Work Order ID 116476

Item Name: Crosstube Turning Detail

DART AEROSPACE LTD	Work Order:	116476
Description: Crosstube Assembly	Part Number:	D407-667-145
Inspection Dwg: D407-667-145 Rev: C		Page 1 of 2

DRAWING NO. D407-667-145	TITLE CROSSTUBE ASS'Y (407 HIGH FWD)	REV. C	DART AEROSPACE LTD ENGINEERING ORDER		D.E.O. NO. D407-667-145-C-1	SHEET NO. SHEET 1 OF 1	SCALE NTS
DRAWN 47	CHECKED ASS	MFG. APPR. 18	APPROVED WD		DE APPR. H		
DATE 11.07.15	DATE 11.07.22	DATE 11.07.22	DATE 11/07/22		DATE 11.07.21

TURNING DETAIL

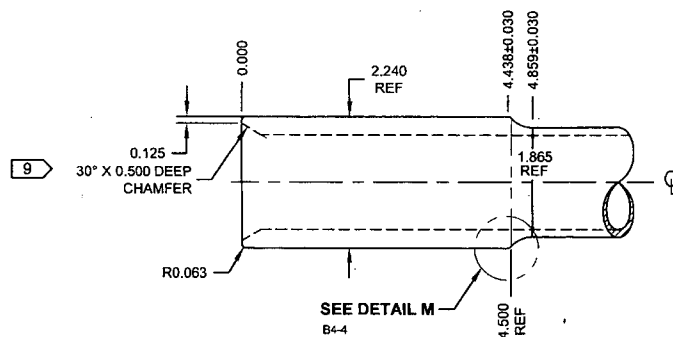
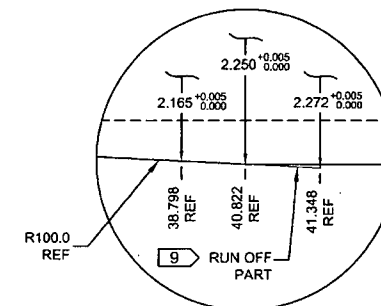
C	REVISE GENERAL NOTES/PART LIST (ZN D7-1); REORGANIZED VIEWS AND REFORMATTED DRAWING TO CURRENT STANDARDS. D3595-063-395 WAS D2856-400-694 (ZN D6-2 & A5-2); REMOVED REF. 7 ADD TOLERANCES (ZN C6-3, C4-3, D2-3); RELOCATED FLAG #6 (ZN A8-3) PER NCR 210; MOVED TURNING DETAIL & UPDATED TOLERANCE TO SHEET 4.	RF	08.11.06
B	ADD HOLES AND NUT PLATES FOR COMPATABILITY WITH BHT/AA SKUDTUBES	PH	05.07.26
A	NEW ISSUE	CP	02.05.08
REV.	DESCRIPTION	BY	DATE
DESIGN	RF	DART AEROSPACE LTD HAWKESBURY, ONTARIO, CANADA	
DRAWN	RF	DRAWING NO.	REV. C
CHECKED	RF	D407-667-145	SHEET 1 OF 4
MFG. APPR.	RF	TITLE	SCALE
APPROVED	RF	CROSSTUBE ASS'Y (407 HIGH FWD)	NTS
DE APPR.	RF	COPYRIGHT © 2002 BY DART AEROSPACE LTD THIS DOCUMENT IS PRIVATE AND CONFIDENTIAL AND IS SUPPLIED ON THE EXPRESS CONDITION THAT IT IS NOT TO BE USED FOR ANY PURPOSE OR COPIED OR REPRODUCED IN ANY FORM OR BY ANY MEANS WITHOUT WRITTEN PERMISSION FROM DART AEROSPACE LTD.

DETAIL P
BONDING STRAP INSTALLATION 2 PL

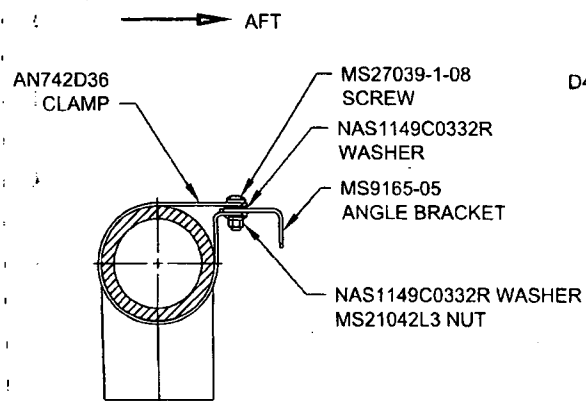
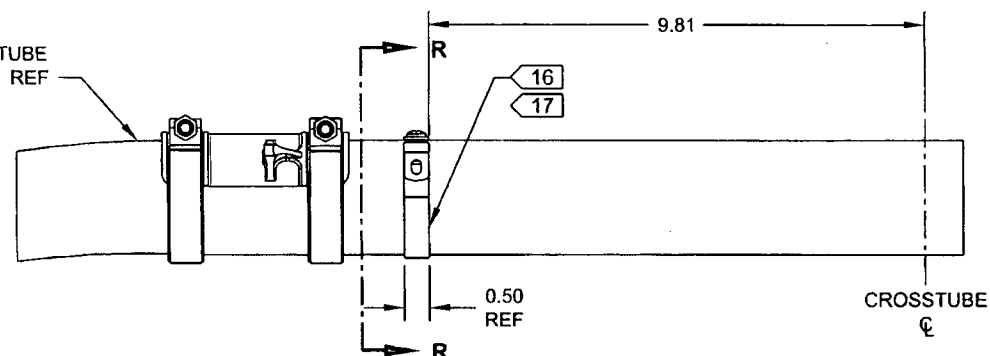
PURPOSE:

ADD ELECTRICAL GROUNDING STRAP

ITEM	QTY	PART NUMBER	DESCRIPTION
1	X	D407-667-145	CROSSTUBE ASSEMBLY (407 HIGH FWD)
10	2	AN742D36	CLAMP
11	2	MS9165-05	ANGLE BRACKET
12	2	MS21042L3	NUT (OR MS21042-3)
13	2	MS27039-1-08	SCREW
14	4	NAS1149C0332R	WASHER (OR AN960C10L)

- 16) MASK AREA UNDER CLAMP PRIOR TO PAINTING
- 17) SEAL EDGES WHERE AN742D36 CLAMP MEETS WITH THE CROSSTUBE USING SIKAFLEX-241/291 OR MIL-S-8802 CLASS B2 OR PROSEAL 890 SEALANT
- 18) PERFORM RESISTANCE CHECK TO ENSURE MAX RESISTANCE IS 10 MILLIOHMS
